**Submission of Further Information (FI)**

**Proposed Temporary Private Vehicle Park (Private Cars) for a Period of 3 Years in “Village Type Development” Zone, Lot Nos. 537 (Part), 538 (Part), 540 S.A (Part) and 541 S.A (Part) in D.D. 218, Ma Kwu Lam Village, Sai Kung North, New Territories**  
(Application No. A/NE-SSH/155)

**Proposed Temporary Private Vehicle Park (Private Cars) for a Period of 3 Years in “Village Type Development” Zone, Lot Nos. 543 (Part), 544 (Part), 546 (Part), 547 (Part), 548 (Part), 549, 550 (Part), 551 (Part), 552 RP (Part), 553, 603 S.A RP, 605 (Part), 606 RP, 607 (Part), 608 (Part), 609 RP and 610 RP (Part) in D.D. 218 and Adjoining Government Land, Ma Kwu Lam Village, Sai Kung North, New Territories**  
(Application No. A/NE-SSH/156)

**Further Information for Planning Application Nos. A/NE-SSH/155&156****Response-to-Comment****Comments from Drainage Services Department received on 28.3.2024**

Goldrich Planners & Surveyors Ltd.
Plan 4.1 ( P 23055B )

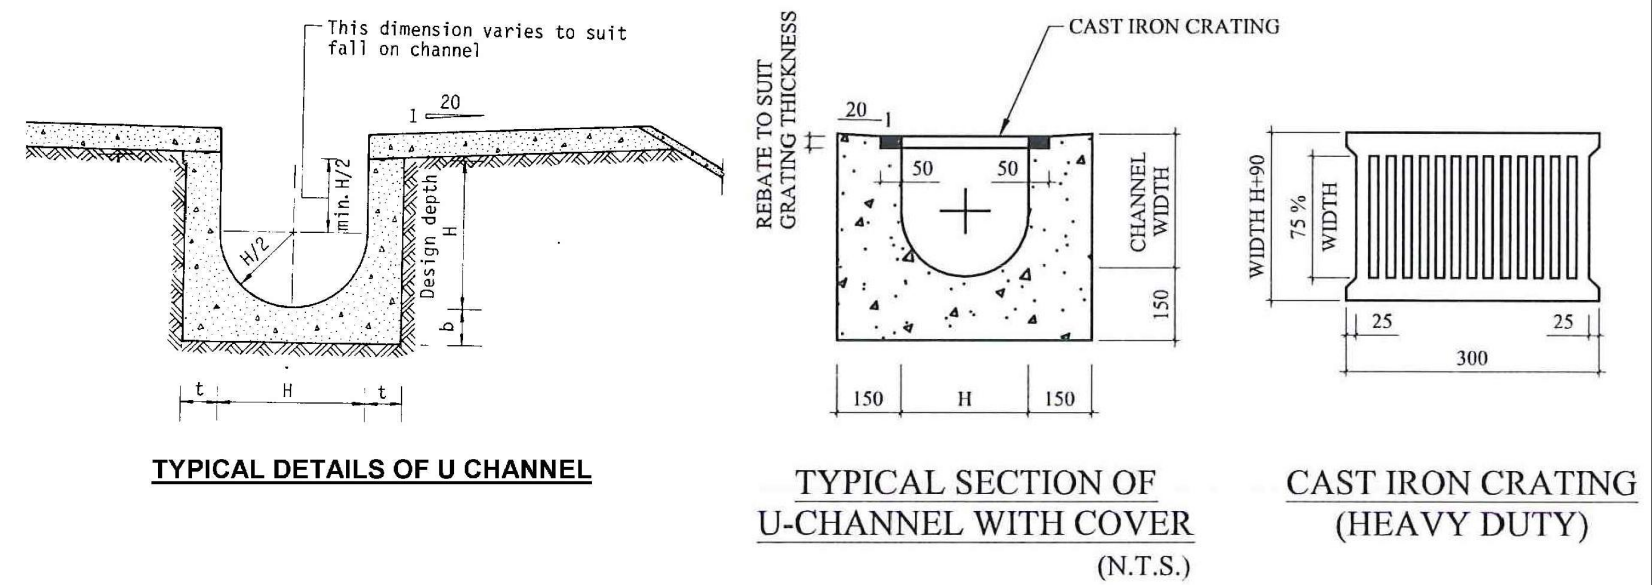
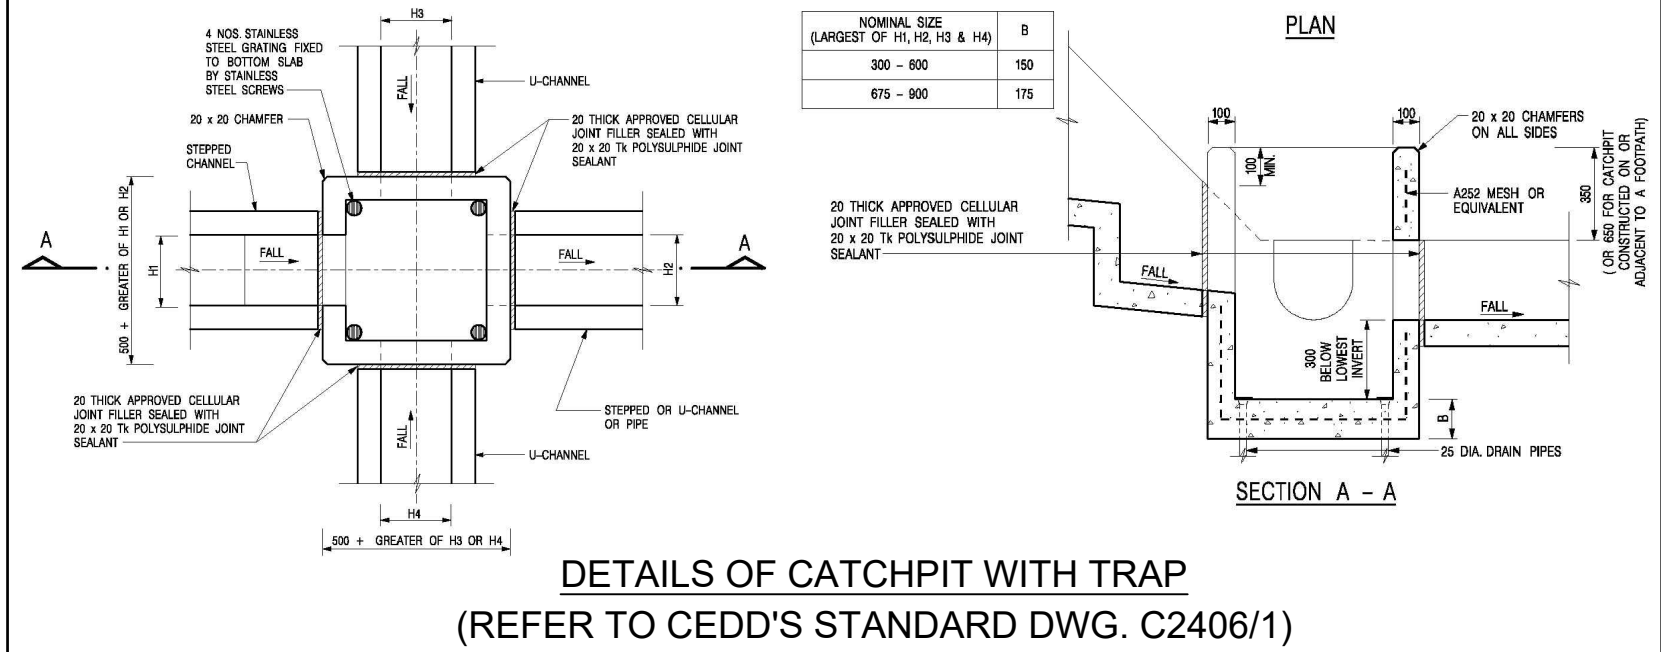
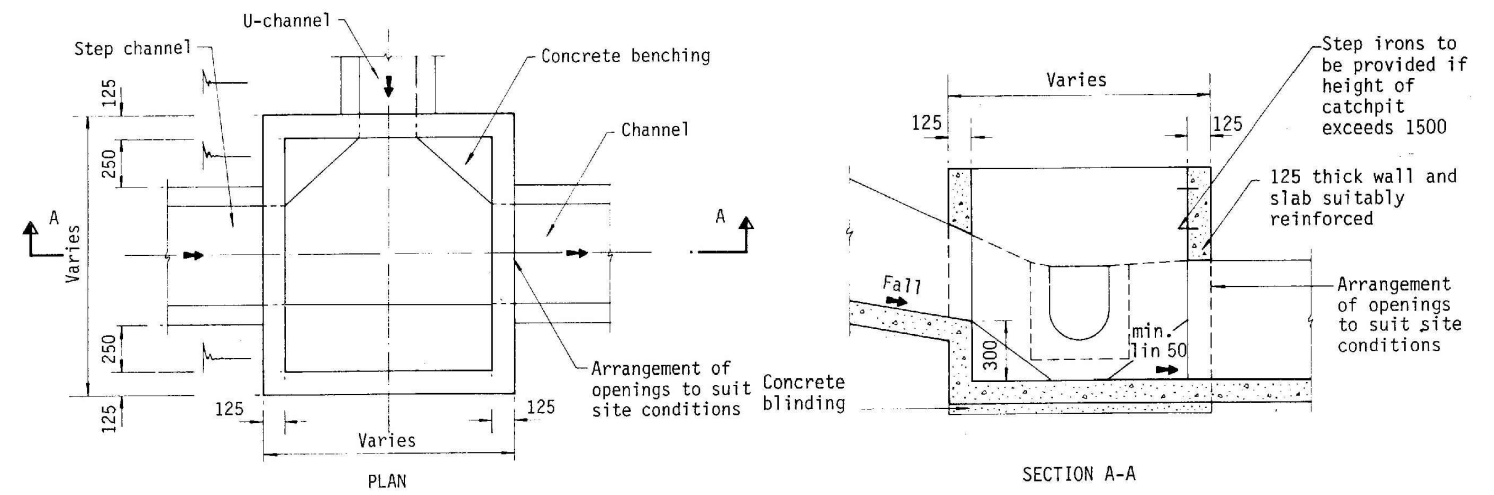
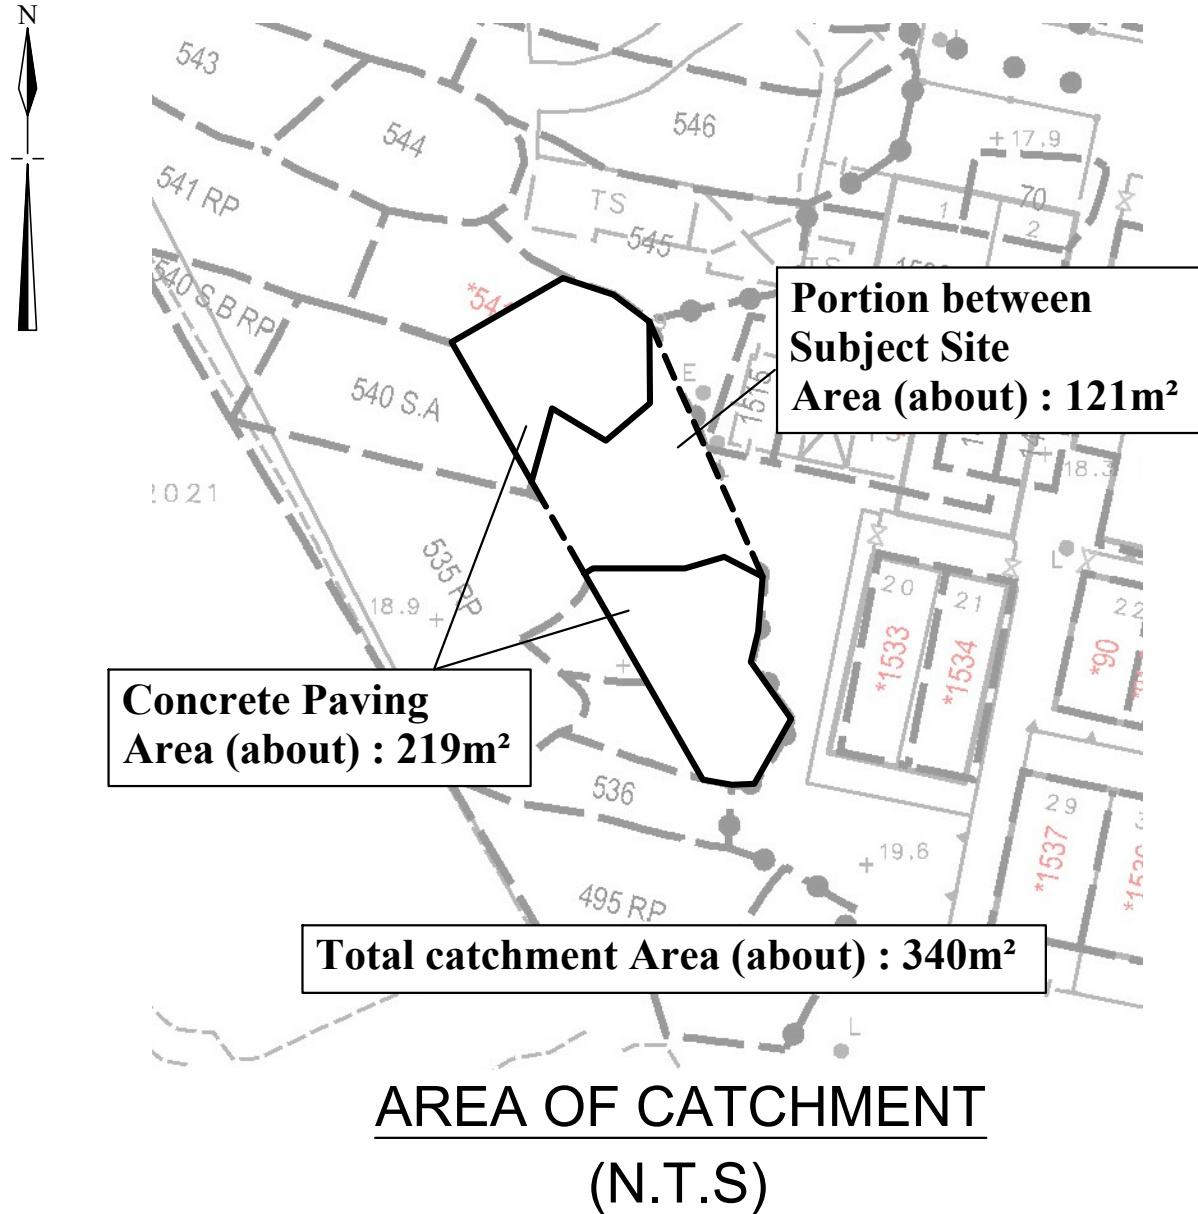
<b>I.</b>	<b>Comment</b>	<b>Response</b>
1.	Proposed finished site formation level and footprint of the proposed development (bearing in mind that the site formation level shall not cause flooding risk to nearby area/premises).	<p>For application no. A/NE-SSH/155, the Site had been formed and the existing formation levels range from +18.9 to +19.4 mPD.</p> <p>For application no. A/NE-SSH/156, the Site had been formed and the existing formation level is at +17.8 mPD.</p> <p>It is anticipated that the Proposed Development shall not impose flooding risks to the surrounding areas with the provision of the proposed drainage facilities (see enclosed drainage proposals of both applications).</p>

2.	Stormwater drainage proposal demonstrating stormwater drainage collection and disposal facilities of adequate flow capacity already exist/to be provided can deal with surface runoff within the lot or flow from adjacent areas including overland flow. The lot owner(s) shall effect the necessary modification/upgrading work of downstream drainage system.	<p>For application no. A/NE-SSH/155, please refer to the enclosed drainage proposal at <b>Plans 4.1 &amp; 4.2.</b></p> <p>For application no. A/NE-SSH/156, please refer to the enclosed drainage proposal at <b>Plans 6.1 &amp; 6.2.</b></p>
